**DESIGN REVIEW BOARD WORK SESSION**

**Design Review Board Case # 2022-0001**

**Block P – 765 John Carlyle – Proposed Revisions to Approved Form, Design and Architectural Character.**

**Figure 4:** Northeast perspective of Block P with callouts to the proposed revisions.

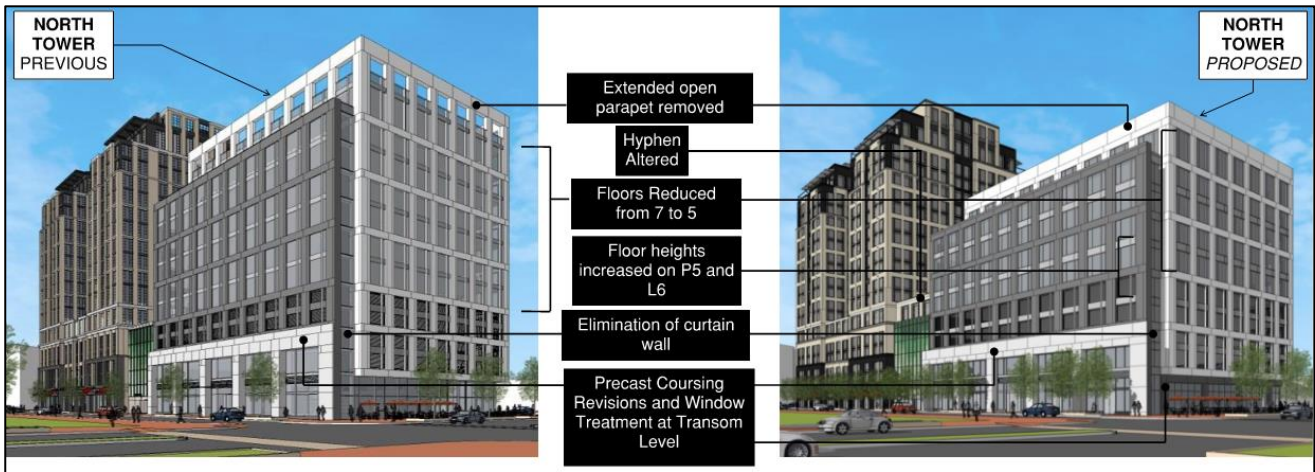
The Applicant proposes to reduce the height of the North Tower by two floors. The Applicant has also removed a key architectural feature from the previous design, an extended open parapet. The ground level of the North Tower will remain retail, however changes are also proposed to the architecture at the pedestrian level as well as to the height of several strategic floors of the building and podium – see **Figure 3**.

Changes are proposed to the hyphen (connection piece) which was previously clad with an intricate façade system of biomorphic chainmail, curtainwall, and vertical metal railings – see **Figure 5**. It ascended 5 stories, with an activated roof terrace above and translucent spandrel glass. Presently, the Applicant proposes a “cap” above the hyphen, which would carry over the architecture of the adjacent southern tower. They have also proposed to increase the floor heights on Level 6 of the tower itself and on Parking Level 5 – which alter the proportions.

**Figure 5:** Graphics and Elevations depicting changes to the Architectural Connector Piece (Hyphen)

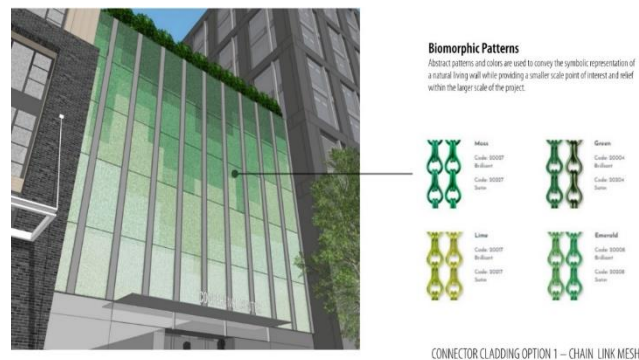
As discussed above, the Applicant proposes a "cap" over the 5-story (e.g., podium) level connector, which separates the two towers. Staff and the DRB always desired for this piece to be a clear and dramatic departure from the architecture of both towers. The request to carry over the architecture from the South Tower is not supported as it eliminates the visually break desired between the two buildings.

**Figure 8:** I. Approved North Tower; II. Proposed North Tower with Reduced Height and Parapet Removal; and, III. Studied Open-Parapet with Proposed Building Height.

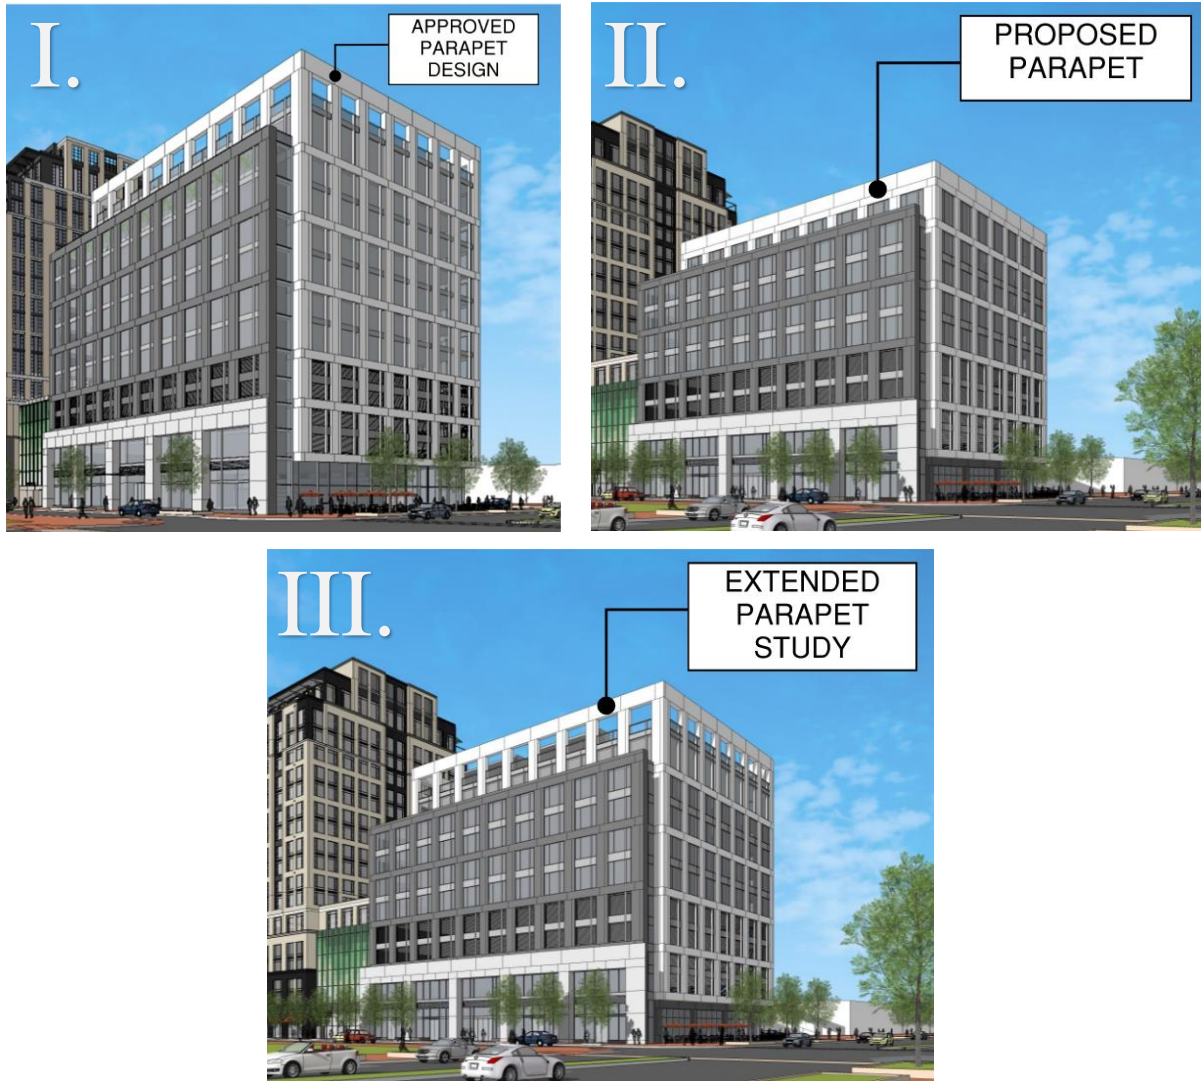
The elimination of the extended open-parapet has visually eliminated an additional perceived floor of the North Tower. Mechanical equipment's is no longer screened to the former degree, and the trees at the terrace level have been eliminated. However, the Applicant has also studied how to incorporate this signature feature with the shortened building – as shown in the **Figures 8-9** below.

The Board agreed with the Applicant's explanation for the changes and noted the volatile nature of the market. They also agreed with the Applicant's decision to revert to the former raised open-parapet condition on the North Tower and the changes to the south tower. Lastly, they agreed to review the revisions on an on-going basis, via circulation of the materials to the members.

**Figure 11:** The Applicant proposes to eliminate the structural glass along Eisenhower Avenue retail level

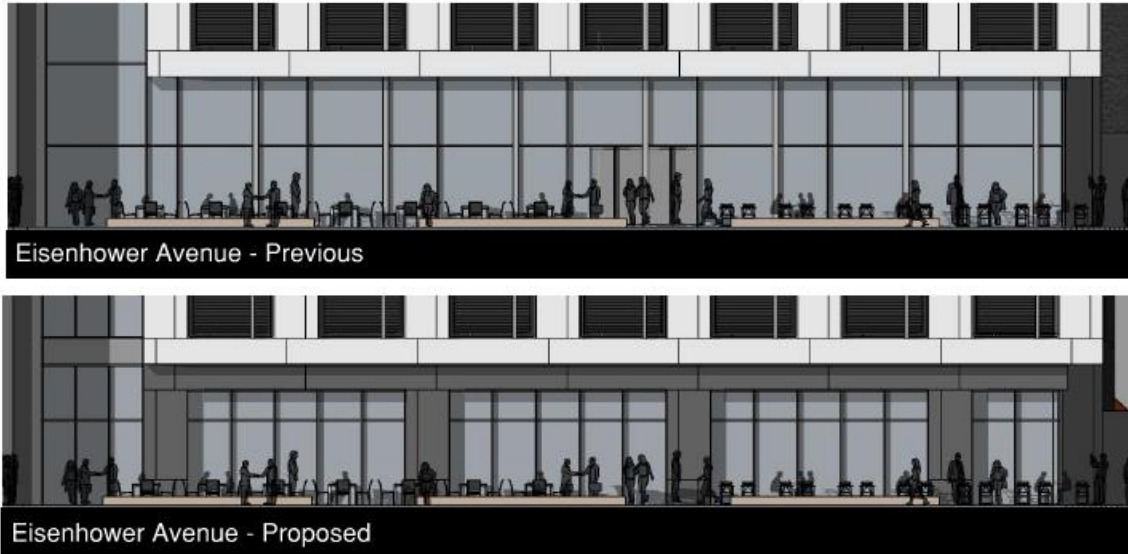
The Applicant has also proposed substantial changes to the ground level of the north tower, which will be occupied by retail storefronts. The changes are most pronounced along the Eisenhower (e.g., north) façade, whereby the curtainwall has been removed and a colonnade of metal panel with intermittent glass introduced.

**Figure 12:** The Applicant proposes to shave 8-inches from strategic levels of the South Tower in order to gain an additional floor.

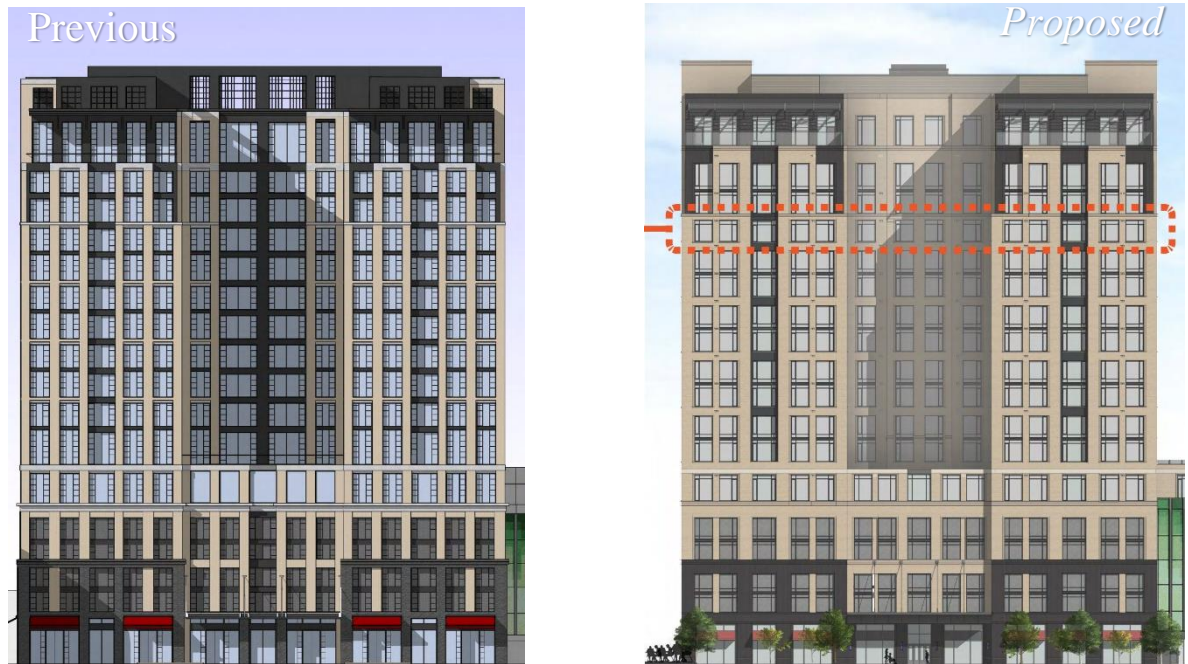
The Applicant has reduced the floors heights on strategic levels, thus gaining an additional floor. This has altered the scale and proportionality of the tower, which Staff does not support. It is also unclear if the Applicant is currently meeting the approved floor area by use; which as noted are regulated by the City Council approved SUP. This effect is subtle by itself, but when taken in conjunction with the design changes previously noted, result in a much less effective vertical expression.

**Figure 13:** The north elevation of the South Tower, from Eisenhower, was once expressed asymmetrically.

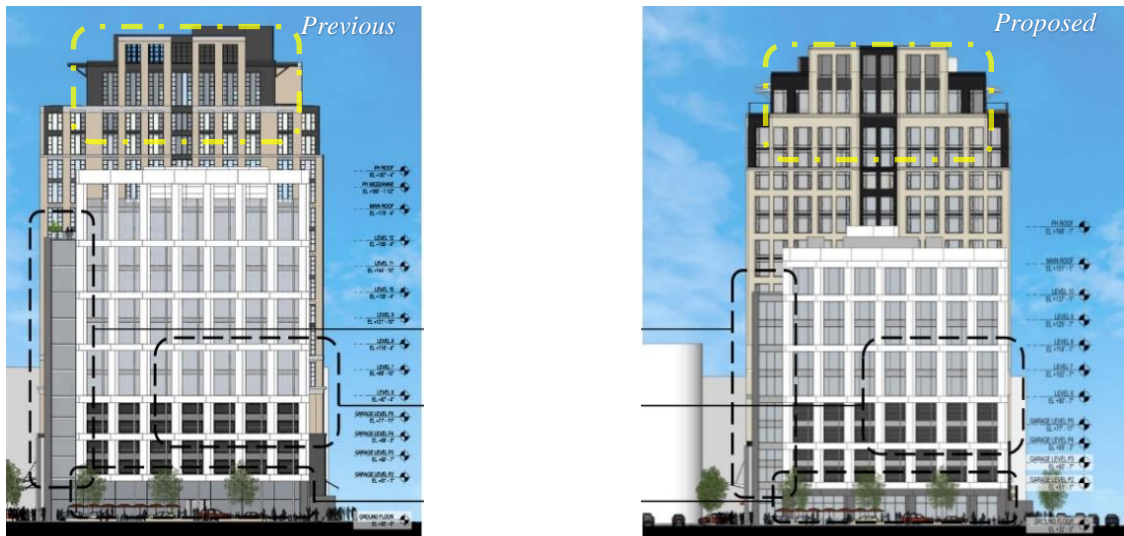
The Applicant proposes significant revisions at the penthouse level, which has among other things, would result in the loss of its asymmetrical expression when viewed from Eisenhower. Staff are unsupportive of this proposed change as the previous expression, in concert with the former roof terrace and canopy, helped celebrate the roof more successfully. The changes detract from the dramatic impact of the roof and penthouse forms. This expression played a significant role in the previous DRB approval, since it was felt that the design had achieved one of the overall design goals of achieving a dramatic roof and skyline form, without resorting to cliches.

**Figure 27:** Changes to the ground-level appearance of the North Tower have resulted in a dramatically less engaging experience from the pedestrian perspective.

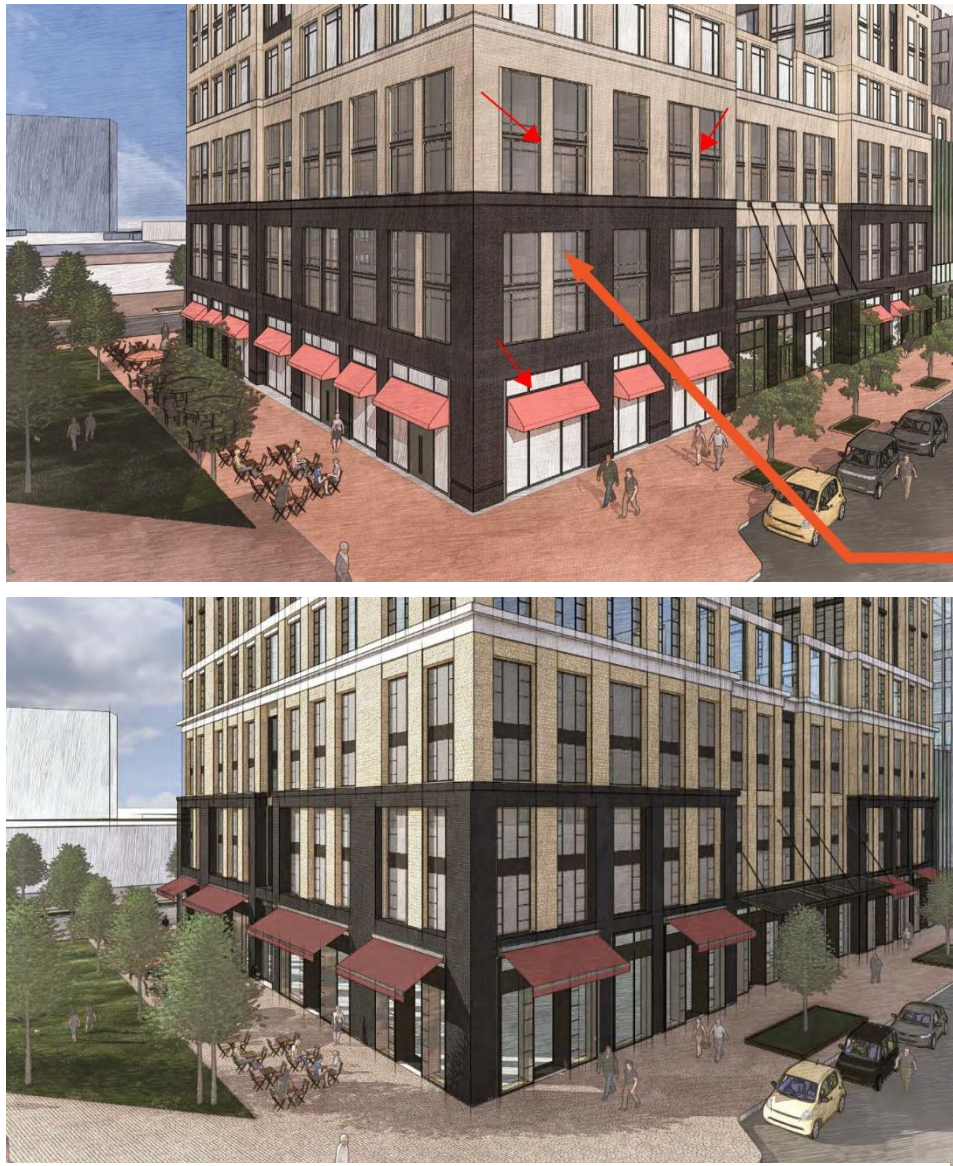
As with the North Tower, changes are proposed to the ground levels of the South Tower pedestrian entryways. Staff are unable to justify the changes, which also appear arbitrary and detract from the tenants of the EESAP, which aspire for high-quality pedestrian realms.
